RE: 17121 Crescent Drive

I reviewed the drawings, and evaluated the site context. My comments and recommendations are as follows:

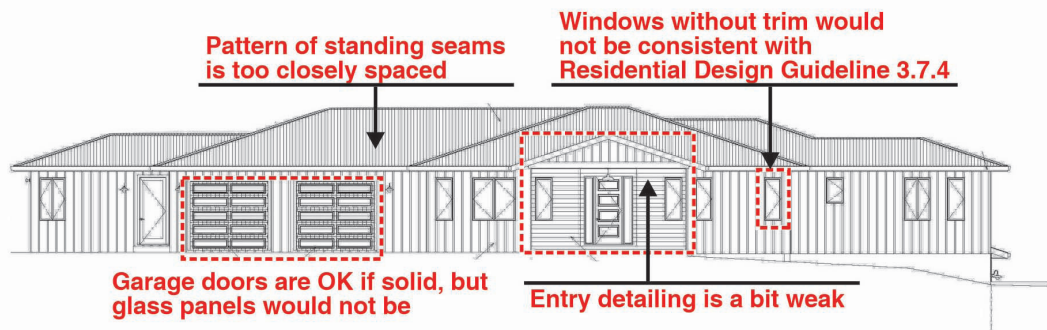
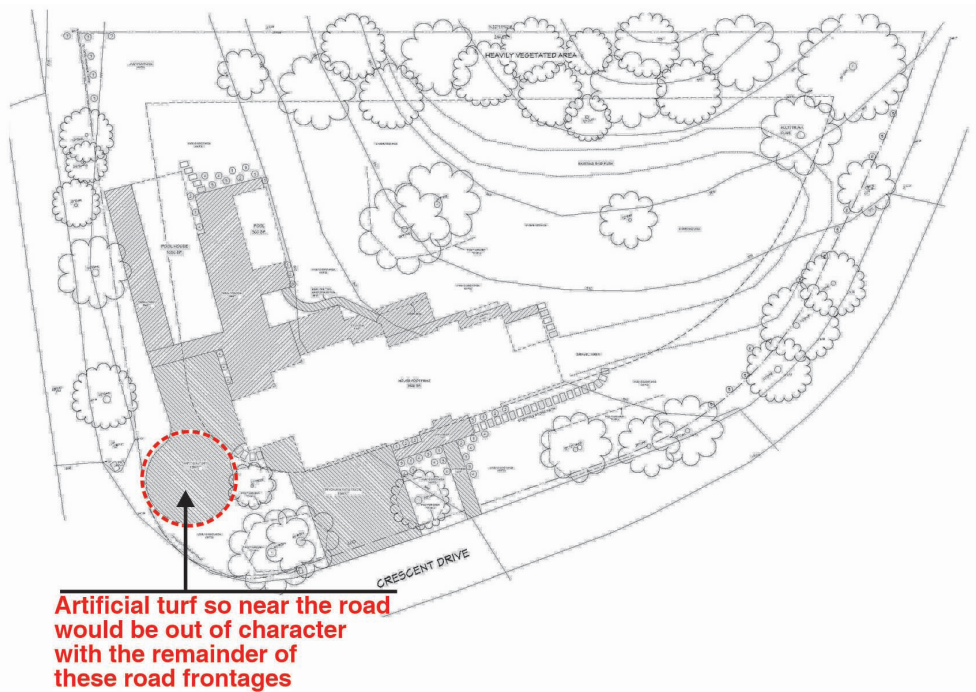
1. The proposed artificial turf area proposed very close to the road would be out of character with the more natural edges along the remainder of the road.

2. The spacing of the standing seams on the metal roof seem too close together, and visually very busy.
3. The entry is a bit weak.
4. Windows without trim would not be consistent with Residential Design Guideline 3.7.4.

1. Eliminate the artificial turf near Crescent Drive in favor of natural landscaping.

2. Refine the standing seam texture of the roof - see example photos below.

3. Refine the entry details - see photo examples below.

Glass Garage Doors: Daytime

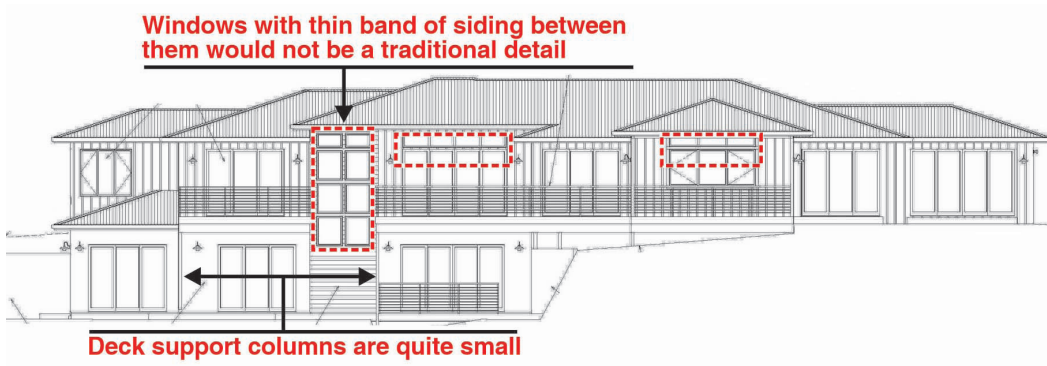
5. The exact materials are not called out for the garage doors except for the note that they are Contemporary Style Roll Up Doors. When I see that note, I would be concerned if the door panels were glass that would provide a visual lantern at night which would be quite out of character for the semi-rural character of this neighborhood - see photo examples below.

4. Add wood trim to all doors and windows consistent with Residential Design Guideline 3.7.4.
5. Provide solid panels in the garage doors unless glazing is limited to the top door panels.
6. Refine the large rear elevation windows by separating upper and lower panes with wood framing in lieu of the segment of wall siding shown.

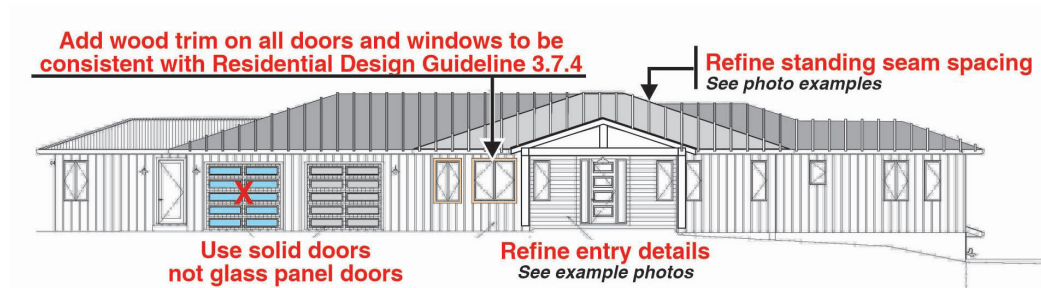
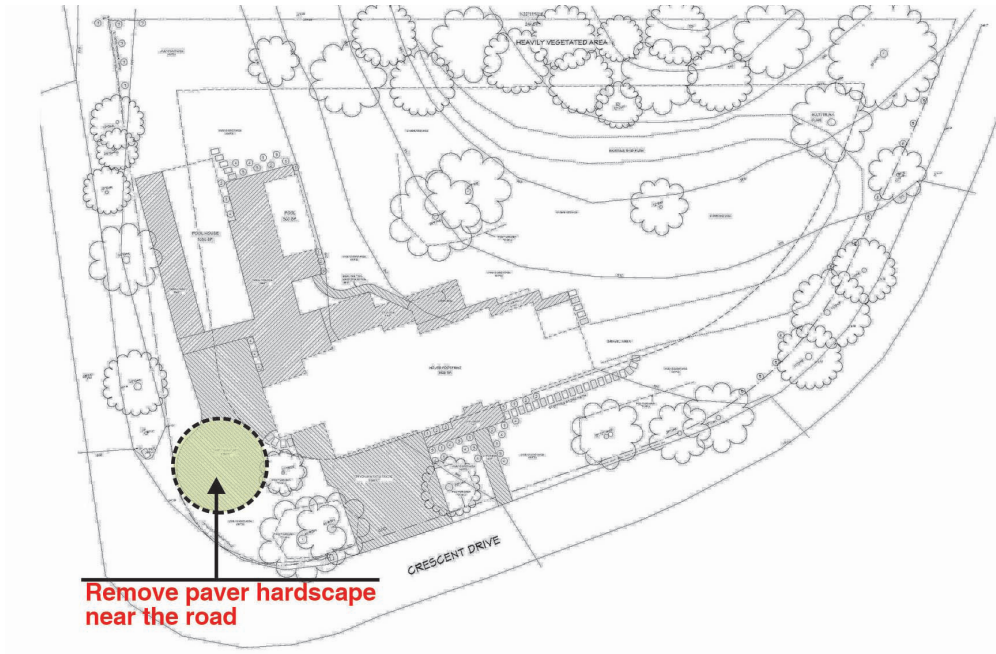
6. The tall multiple window areas on the rear elevation do not seem to yet have the appropriate traditional detailing for the home's proposed architectural style.
7. The Town's Hillside Design Guidelines generally discourages this type of open deck support shown at the rear of the house, but the portion of the rear elevation where this occurs is small and not visually awkward. However, the columns on the rear elevation supporting upper level decks are rather skinny compared to their height.

7. Increase the size of the rear deck supports.
